Why the LLTNPA should reject the Cononish Gold Mine planning application

Objection to Planning Application 2017/0254/MIN Development of a Gold Mine, Glen Cononish, Tyndrum

Ore Processing Building

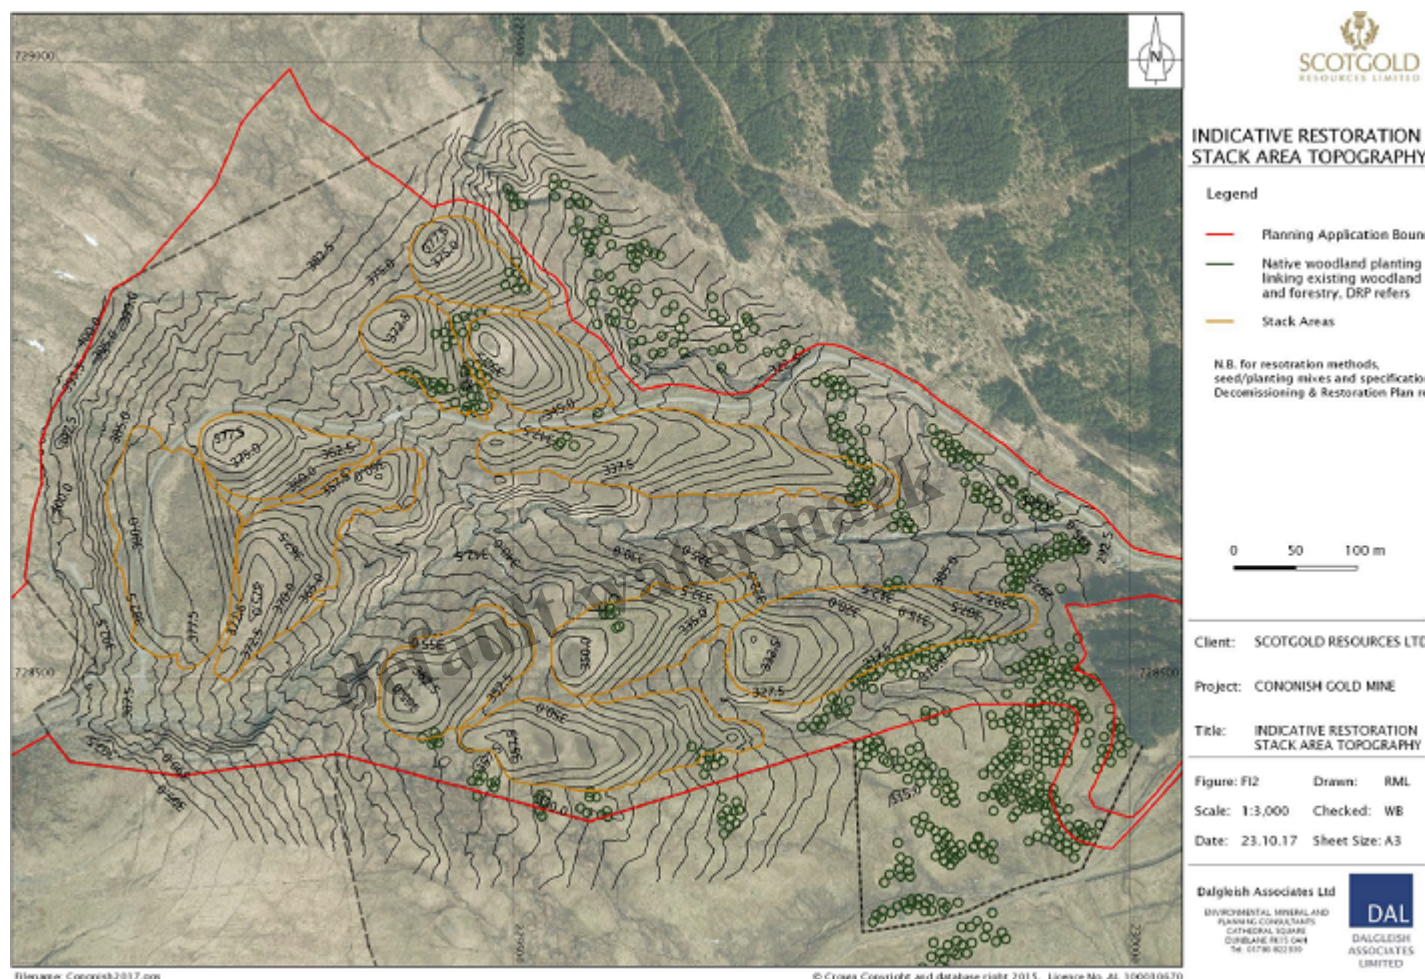
The building now proposed is 80 metres by 30 metres, nearly 50% bigger than the average Aldi store, and has a 6% larger footprint than that approved in 2015. The design is also more monolithic in appearance with reduced screen bunding and consequently will be an even more prominent feature in the landscape.
